Transmission Expansion Advisory Committee FirstEnergy Supplemental Projects

August 5, 2025

Need Number: PN-2023-029

Process Stage: Re-present Solution – 08/05/2025 (Changes in Red)

Penelec Transmission Zone M-3 Process Perry – Ashtabula – Erie West 345 kV Line

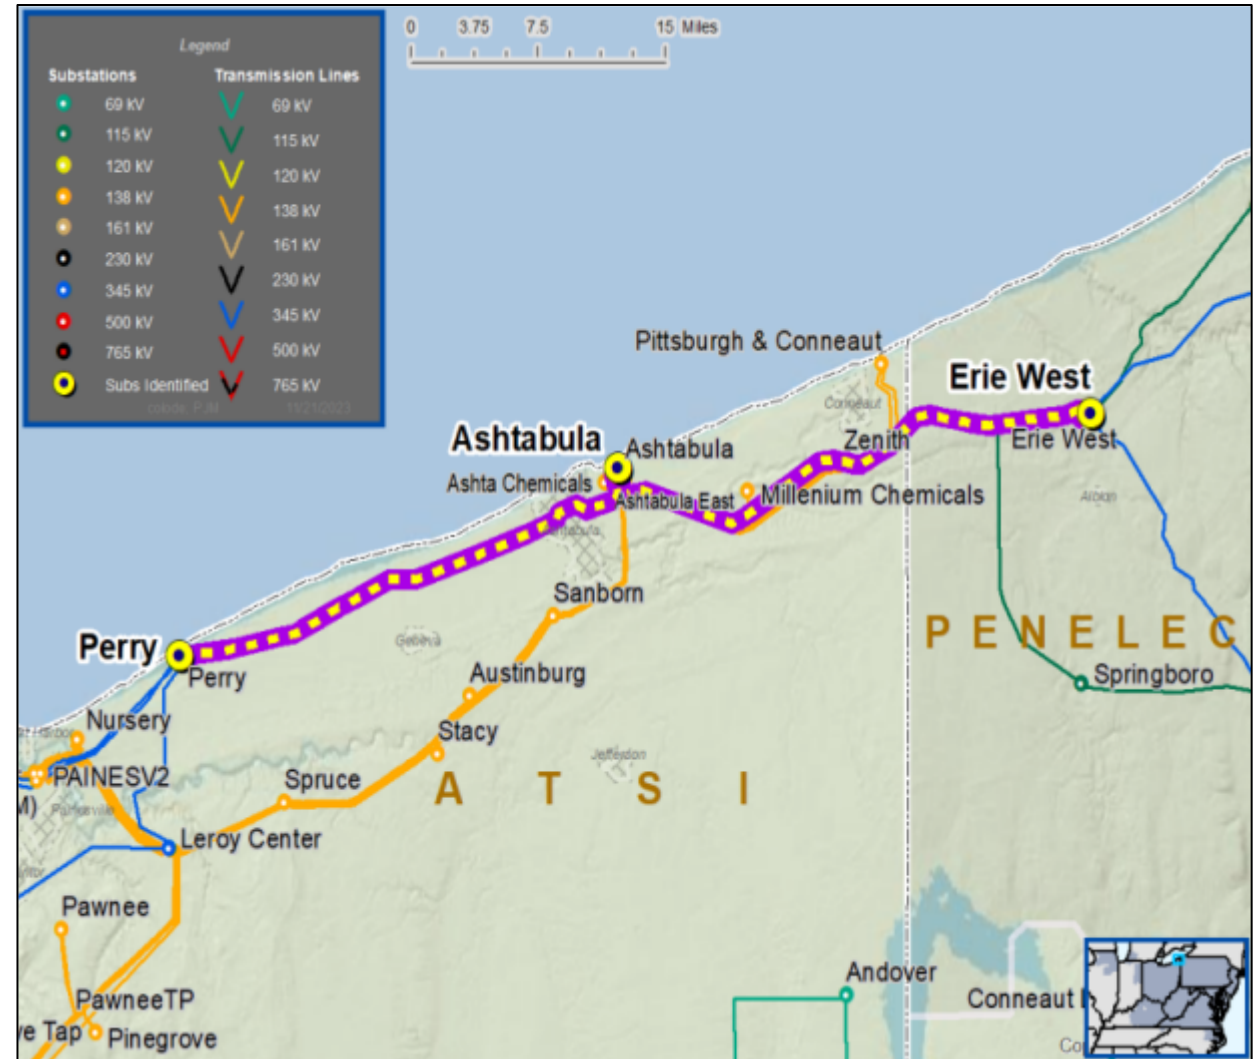
Estimated Project Cost: ~~\$38.7M~~ \$52.4 M

Projected In-Service: ~~04/09/2027~~ 5/31/2027

Model: ~~2023 Series 2028 RTEP Case Summer (50/50)~~ 2024 RTEP model for 2029 Summer (50/50)

- Rebuild the 7.2 mile, Penelec section of the Ashtabula – Erie West 345 kV Line

- Replace disconnect switches.

- Revise relay settings
